Sundry Print Report

Well Name: RDX 15	Well Location: T26S / R30E / SEC 15 / NWNE / 32.04862 / -103.867977	County or Parish/State: EDDY / NM
Well Number: 12	Type of Well: OIL WELL	Allottee or Tribe Name:
Lease Number: NMNM100558	Unit or CA Name:	Unit or CA Number:
US Well Number: 3001537094	Operator: WPX ENERGY PERMIAN LLC

Notice of Intent**Sundry ID:** 2861690**Type of Submission:** Notice of Intent**Type of Action:** Plug and Abandonment**Date Sundry Submitted:** 07/07/2025**Time Sundry Submitted:** 10:26**Date proposed operation will begin:** 10/01/2025**Procedure Description:****Surface Disturbance****Is any additional surface disturbance proposed?:** No**NOI Attachments****Procedure Description**

**Permanent Abandonment of Federal Wells
Conditions of Approval**

WELLBORE DIAGRAM - PROPOSED

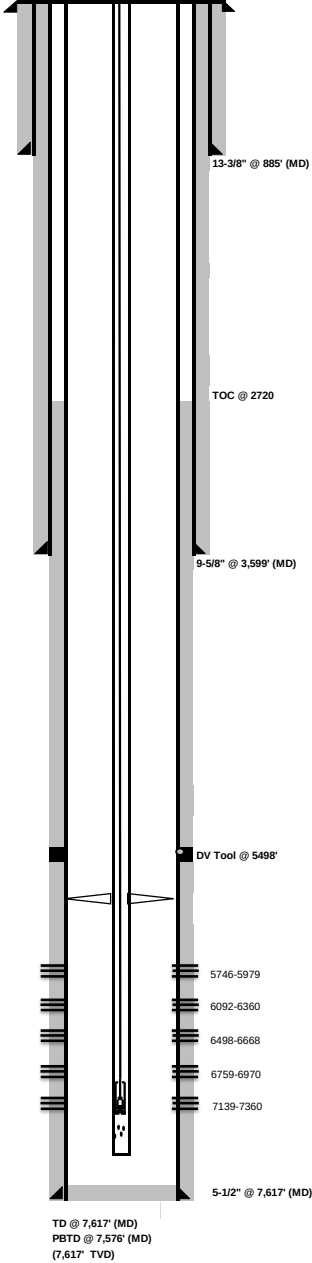
Proposed:
1. Perf @ 100'
2. Circ 35 sx CI CI from 100' to surface.
3. Cut WH off 3' BGL, Set dry hole marker.

Proposed:
1. Perf @ 1109'
2. Sqz 160 sx CI C from 1109'-660'. WOC & tag. (Shoe @ 885'; Rustler @ 718'; Salado @ 1059')

Proposed:
1. Perf @ 1614'
2. Spot 40 sx CI C from 1614'-1500'. WOC & Tag (Castile @ 1564')

Proposed:
1. Spot 25 sx CI C from 3709'-3500'. WOC & Tag. (Shoe @ 3599', Delaware @ 3659', Salt @ 3634')

Proposed:
1. Spot 25 sx CI C from 4753'-4540. (Cherry Canyon @ 4703')

DV Tool @ 5498'
Proposed:
1. Set CIBP @ 5696'. Circ 10# salt gel. Leak test.
2. Spot 35 sx CI C from 5740'-5410'. WOC & Tag (Perfs @ 5746', DV Tool @ 5498')
3. CBL on file - 8/21/12 shows TOC @ 2720'.

Proposed:
1. Spot 25 sx CI H from 7545'-7380'. (Bone Spring @ 7495')

1. MIRU P&A unit. POOH 2 7/8" tubing and rods from 7404'.
2. Spot 25 sx CI H from 7545'-7380'. (Bone Spring @ 7495')
3. Set CIBP @ 5696'. Tag. Circ 10# salt gel. Pressure Test 500 psi 30 min. CBL (8/21/12) on file. TOC @ 2720'. **CBL REVIEW WED AND VERIFIED**
4. Spot 35 sx CI C from 5740'-5410'. WOC & Tag (Perfs @ 5746", DV Tool @ 5498')
5. Spot 25 sx CI C from 4753'-4540'. (Cherry Canyon @ 4703')
6. Spot 25 sx CI C from 3709'-3500'. WOC & tag. (Shoe @ 3599', Delaware @ 3659', B Salt @ 3634')
8. Perf @ 1614'. Sqz 40 sx CI C from 1614'-1500'. WOC & Tag. (Castile @ 1564')
9. Perf @ 1109'. Sqz 160 sx CI C from 1109'-660'. WOC & Tag. (Shoe @ 885', Rustler @ 718', Salado @ 1059')
10. Perf @ 100'. Sqz 35 sx CI C from 100' to surface. Verify at surface.
11. Cut wellhead off 3' BGL, set dry hole marker.
